# ALERT SERVICE BULLETIN

**SUBJECT: TIME LIMITS - MAINTENANCE CHECKS - Fan assembly**

**Check of fan assembly bearings**  
ATA 65

Revision No.	Date of issue
Revision 0	2017-07-03

Figure 1

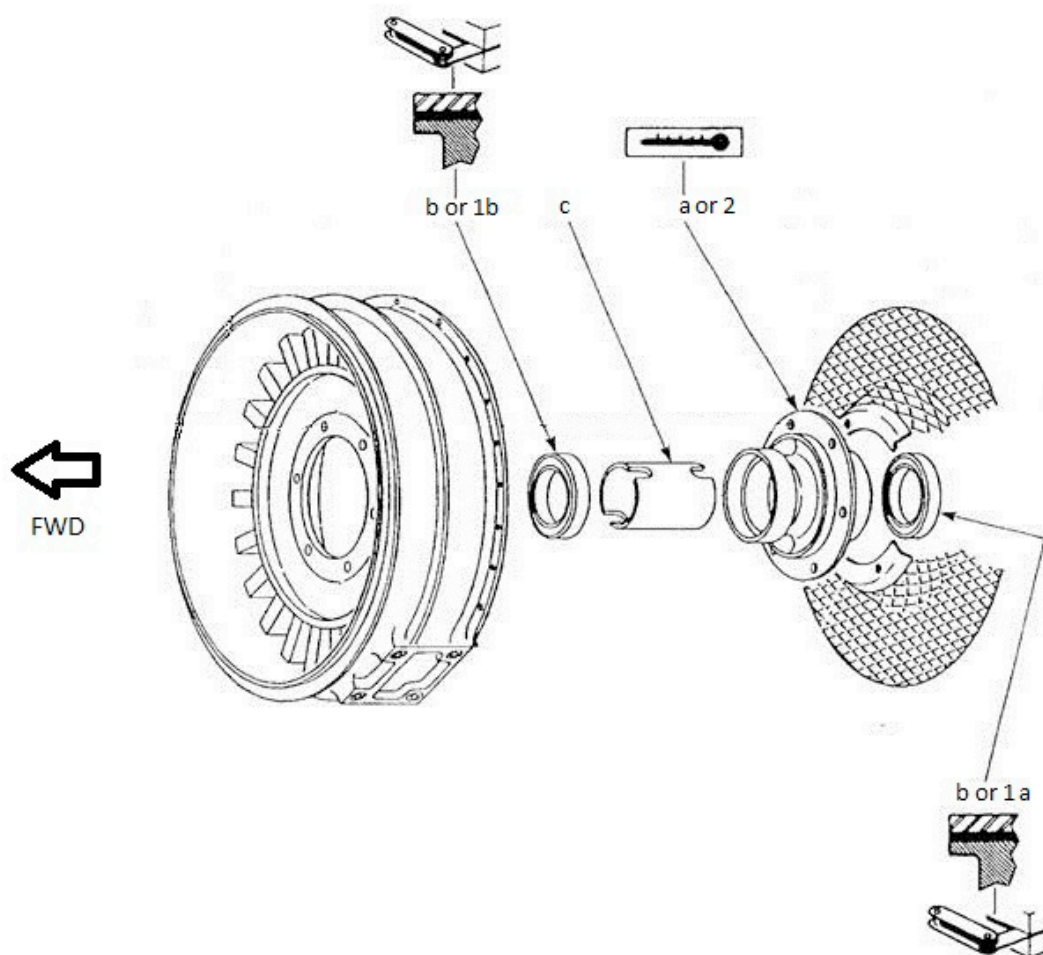
- . If the difference is greater than 0.75 ips (Figure 1)
    - Remove the fan assembly as per MET Work Card 65.10.00.401,
    - Remove unit (a) equipped with bearings from the fan assembly,

- Replace former fan bearings (b) with new bearings (1) in accordance with the procedure described in Appendix 4.B. or return unit (a) equipped with bearings for replacement of the fan bearings,

- Install unit (a or 2) equipped with bearings in the fan assembly,
    - Install the fan assembly as per MET Work Card 65.10.00.401,
    - Comply with paragraph 3.B.6.

As per Figure 1

- Removal of bearings (b):

- . Heat unit (a) equipped with bearings,

**THE UNIT EQUIPPED WITH BEARINGS IS MADE  
OF ALUMINUM. DO NOT HEAT TO A  
TEMPERATURE OF MORE THAN 90°C.**

- . Extract bearings (b) using fan bearing extractor (zz),
  - . Remove spacer (c),
  - . Visually check for correct condition of the removed parts (no wear or fretting) and, if necessary, repair as per MTC.
- Installation of bearings (1) and spacer (c) on unit (a):
- . Place unit (a) in a climatic chamber at 80°C for 30 minutes,
  - . On unit (a), install rear bearing (1a) using fan bearing fitting tool (yy),
  - . On unit (a), install front bearing (1b) and spacer (c) using fan bearing fitting tool (yy),
  - . Let the assembly return to room temperature,
  - . Continue reassembly of the fan assembly as per paragraph 3.B.5.
